Tauranga District Council
 Private bag 12022
 Tauranga

Mauao Slope Monitoring July 2007; pipe trench adjacent to 4WD track dropout

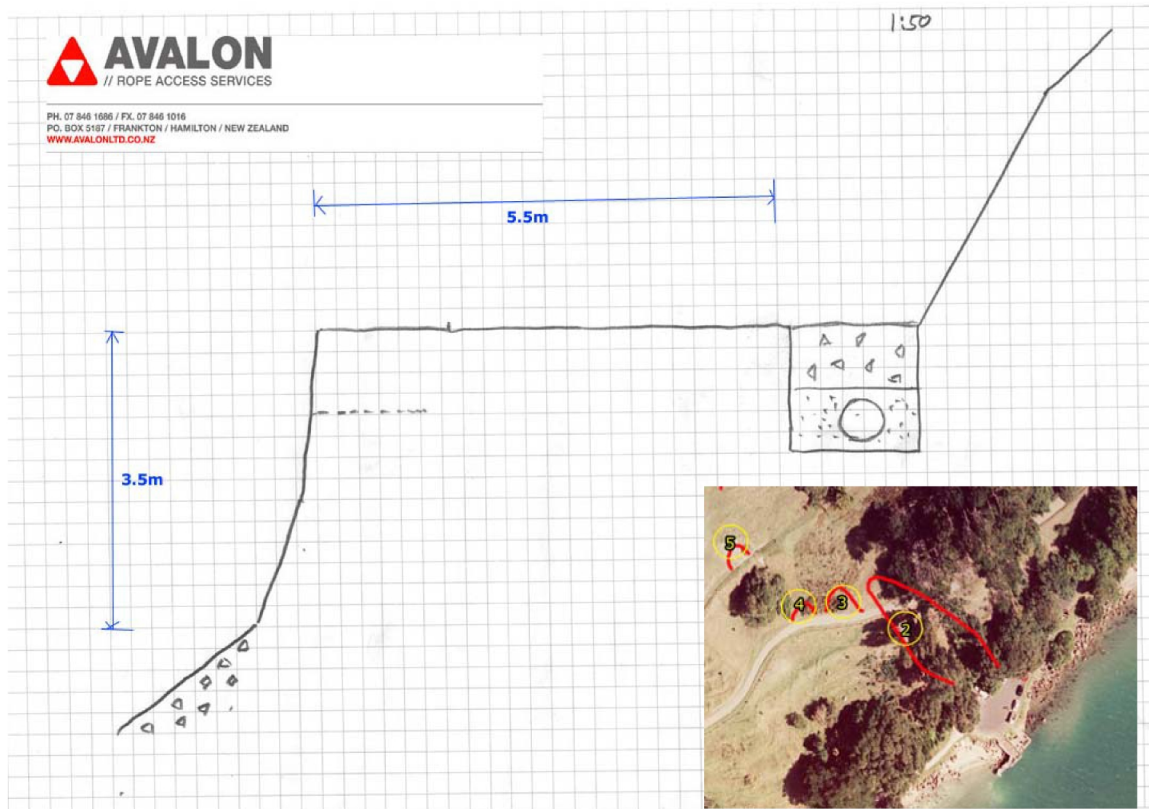
Further to our discussion on site please find below a sketch section of a 'dropout' of particular concern below the 4WD track, between the base and the water tower. The slip is approximately at location 2 in the inset photograph.

It is fortunate that the near vertical face did not fail further in the preceding two years as the slope is overly steep for these materials; the upper metre or so appears to be fill and below this lies a chaotic colluvial mix, predominantly clayey but with sandy layers and buried topsoil.

Tension cracks can be seen up to 500mm back from the crest.

My first concern on seeing the new trench was that construction might have the potential to alter the local groundwater and that this might not be ideal, considering the adjacent marginally stable slope.

The lower 700mm or so depth of trench is being back filled with pumice sand, which should provide excellent drainage down the trench, however, the colluvium contains interlayered clay and sand therefore the excavation still has the possibility of creating new flow paths.

The excavated colluvium is being reused for capping above the pumice sand. Much of this material is clay and this presents two issues: 1. it is impossible to compact sufficiently (in the prevailing wet conditions) and 2. it might allow pressure to build up within the trench.

The contractor on site (s 7(2)(a) - Privacy) informed me that he has been having trouble getting compaction on the wet clay. To assist with this he installed one transverse drain to the trench (and this can be seen flowing just south of the slip). He was intending to install additional drainage but this was apparently stopped for financial reasons.

I think the cost benefit of additional drainage and importing a more freely draining material for the capping would be likely to be justifiable considering the likely costs of further slips, which could potentially leave the track unusable by vehicles.

I understand that the slip is scheduled for some form of remedial stabilisation. To minimise the risks it would probably have been preferable to stabilise the slope prior to trenching, however, I would now recommend that the work now be commenced asap.
